P802.11wTM/D2.23

Draft Standard for Information Technology - Telecommunications and information exchange between systems -

Part 11: Wireless LAN Medium Access Control (MAC) and Physical Layer (PHY) specifications:

Amendment 5: Protected Management Frames

Figure 5-13—Establishing pairwise and group keys

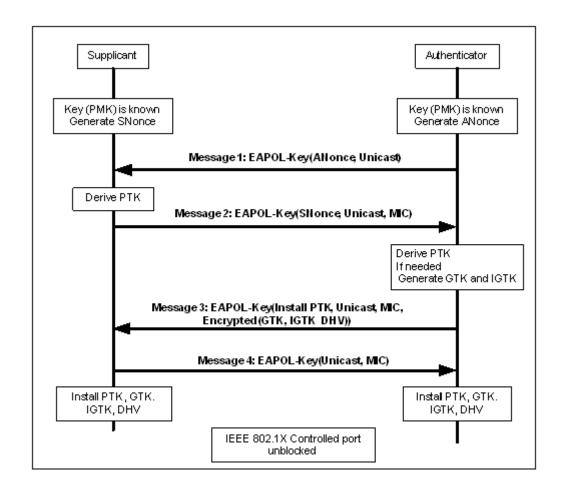
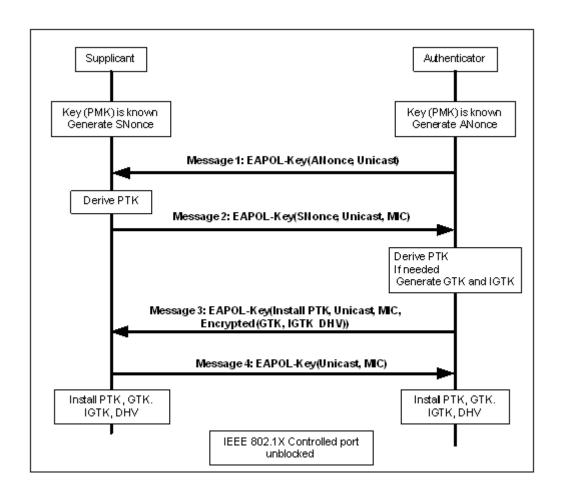
Replace Figure 5-13 with the following figure, with the changes being the inclusion of "IGTK" in message 3 and in both the Supplicant and Authenticator boxes that begin with "Install" and in the Authenticator box to "Generate GTK and IGTK":

Figure 5-14 — Delivery of subsequent group keys

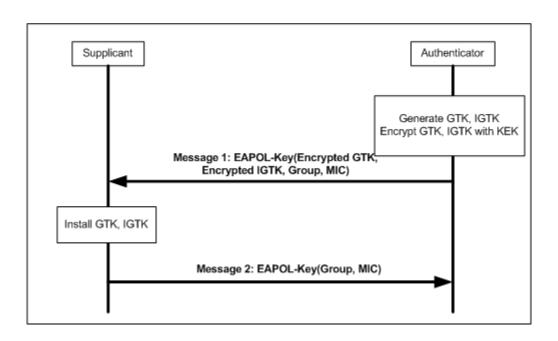
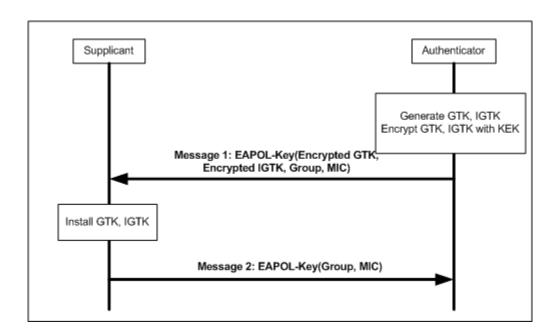
Replace Figure 5-14 with the following figure, with the changes being the inclusion of "Encrypted IGTK" in Message 1, "IGTK" in the Authenticator box beginning with 'Generate" and "IGTK" in the Supplicant box beginning with "Install"; the update to the 2nd box on the right has intentionally fixed 802.11-2007 to correctly state "Encrypt GTK, IGTK with KEK":

Figure 8-18 — Nonce Construction

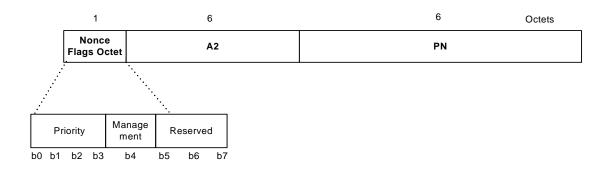
Replace Figure 136-8-18 with the following figure replacing "Priority Octet" with "Nonce Flag Octet", and addition of "Management" as bit 4 of this octet.":

EDITORIAL NOTE: ANA must be requested for this bit (4). There have been issues editing the above Figure and thus is left as B4....readers should note that until ANA assigns this bit, it should read <ANA>, pending ANA assignment.

Figure 8-33—Sample 4-Way Handshake

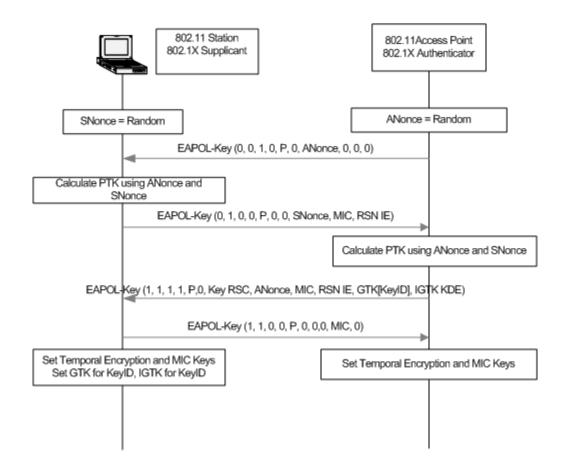
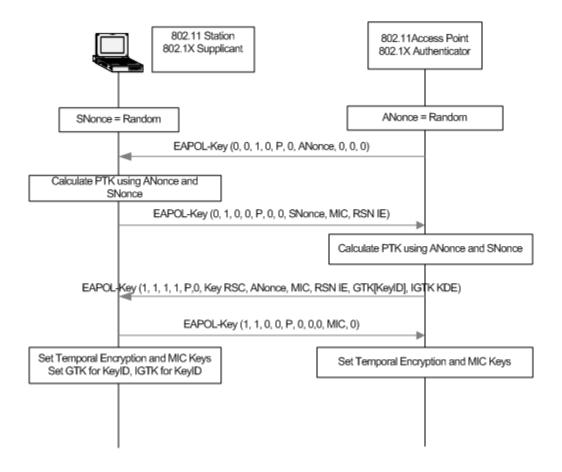
Replace Figure 151 with the following Figure, with the updates including IGTK KDE on the 3rd EAPOL-Key message and "IGTK for Key ID" on the 3rd supplicant box:

Figure 8-34—Sample Group Key Handshake

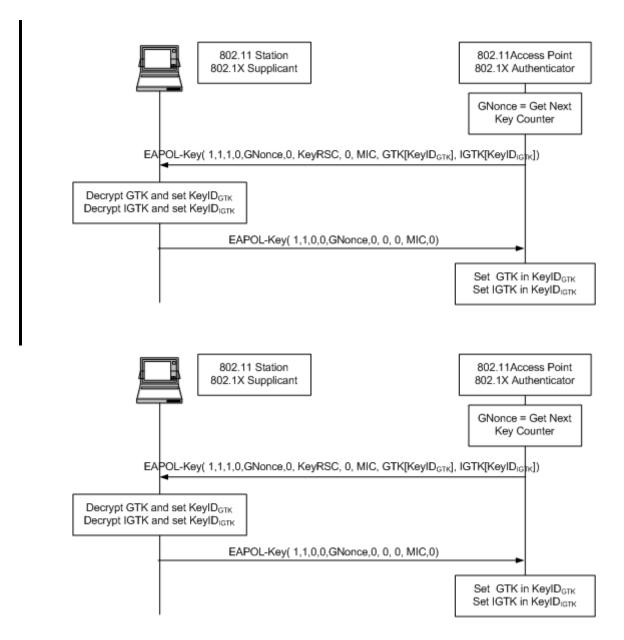
Replace Figure 8-34 with the following Figure, with the updates including IGTK on the first EAPOL-Key message and 2nd supplicant box, reformatting the first message above the message arrow and IGTK and new subscripts to the last Authenticator box:

Figure 8-35—RSNA Supplicant key management state machine

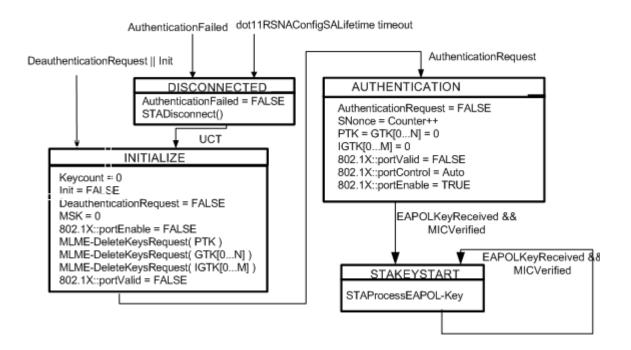
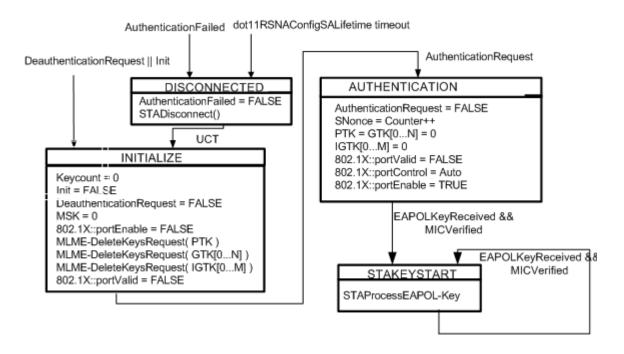
Replace Figure 8-35 with the following figure updating "Snonce" to "SNonce", adding "IGTK[0...M] = 0" in the "AUTHENTICATION" box and "MLME-DeleteKeysRequest(IGTK[0...M])" to the "INITIAL-IZE" box:

Figure 8-37—Authenticator state machines, part 1

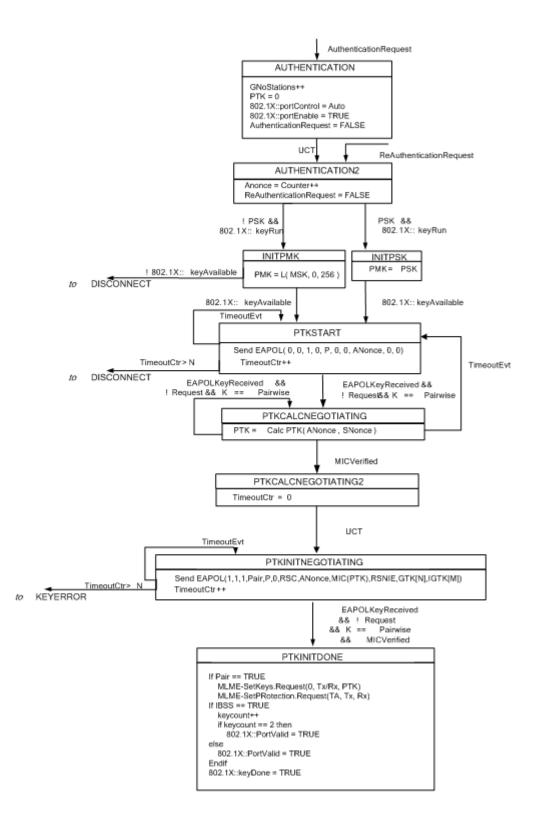
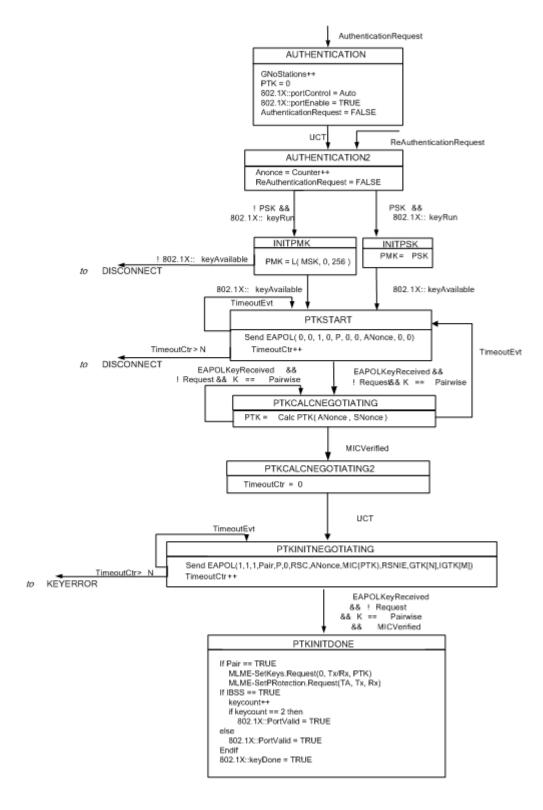
Replace Figure 8-37 with the following Figure, with the updates being fixing Anonce with ANonce in the PTKSTART, PTKCALCNEGOTIATING, and PTKINITNEGOTIATING and the insertion of "IGTK[M]" in the PTKINITNEGOTIATING box:

Figure 8-40—Authenticator state machines, part 4

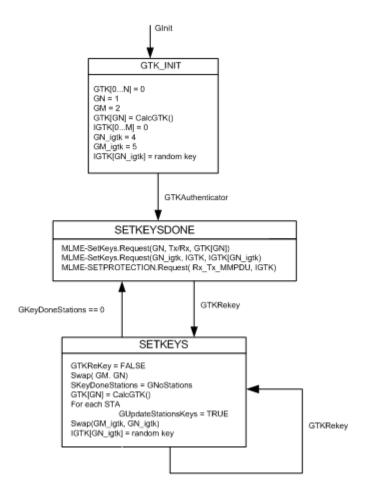
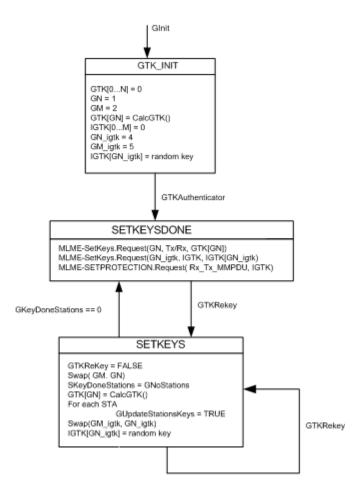
Replace Figure 8-40 with the following Figure, with the updates being the addition into the GTK_INIT state (semicolons showing linebreaks): "IGTK[0..M] = 0; GN_igtk = 4; GM_igtk = 5; IGTK[GN_igtk] = random key"; addition into SETKEYSDONE state: "MLME-SETKEYS.request(GN_igtk, IGTK, IGTK[GN_igtk]); MLME-SETPROTECTION.request(Rx_Tx_MMPDU, IGTK)". Addition into SET-KEYS state: "Swap(GM_igtk, GN_igtk); IGTK[GN_igtk] = random key".insertion of "IGTK[M]" in the PTKINITNEGOTIATING box:

Figure 11A-13—Authenticator R1KH state machine (part 1)

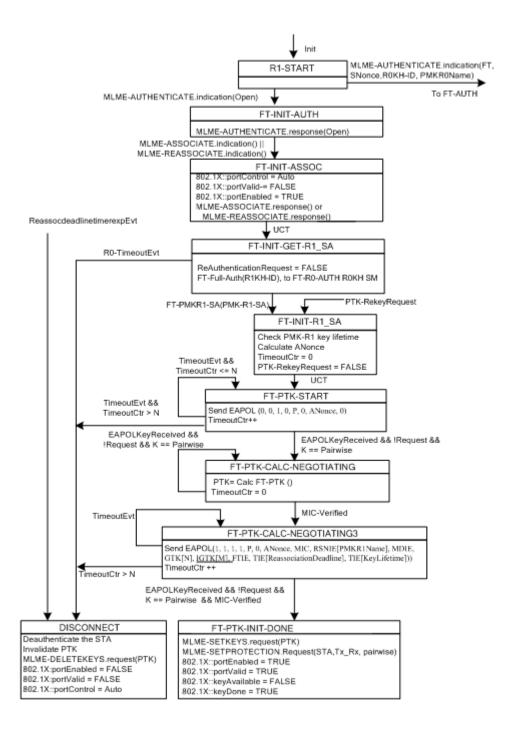
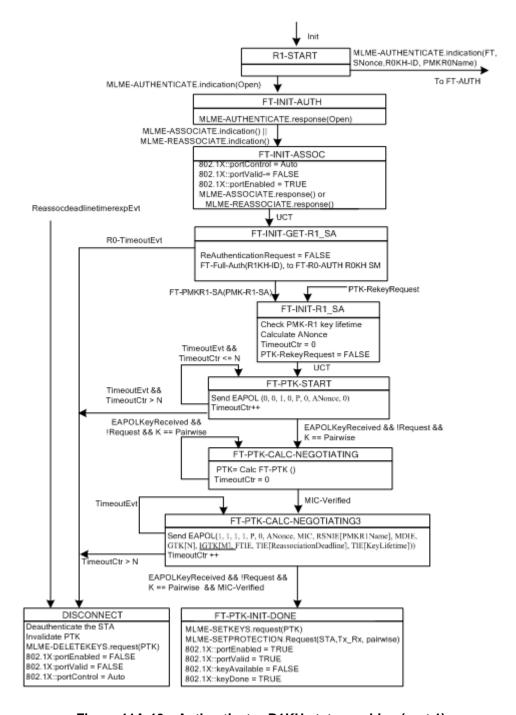
Replace Figure 11A-13 with the following Figure, with the updates being including "IGTK[M]" in the FT-PTK-CALC-NEGOTIATING3 box:

Figure 11A-14—Authenticator R1KH state machine (part 2)

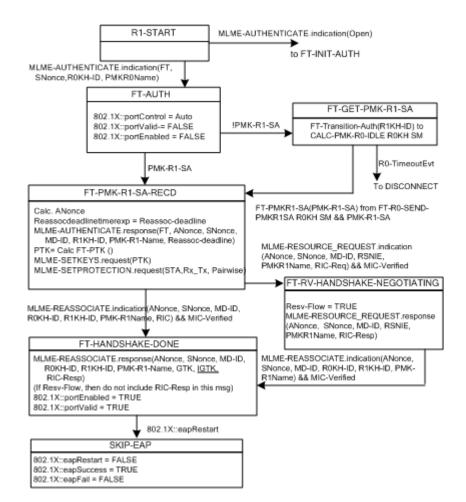
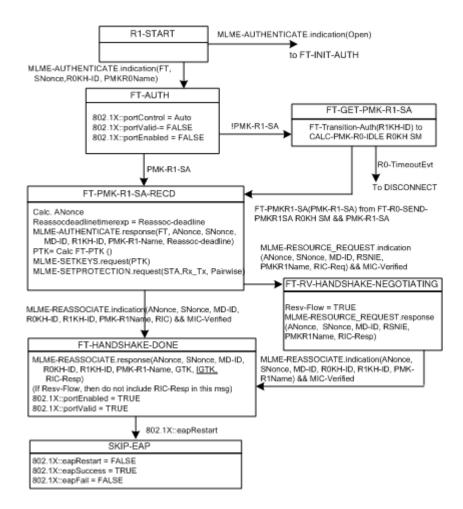
Replace Figure 11A-14 with the following Figure, with the updates being including "IGTK" in the FT-HANDSHAKE-DONE box:
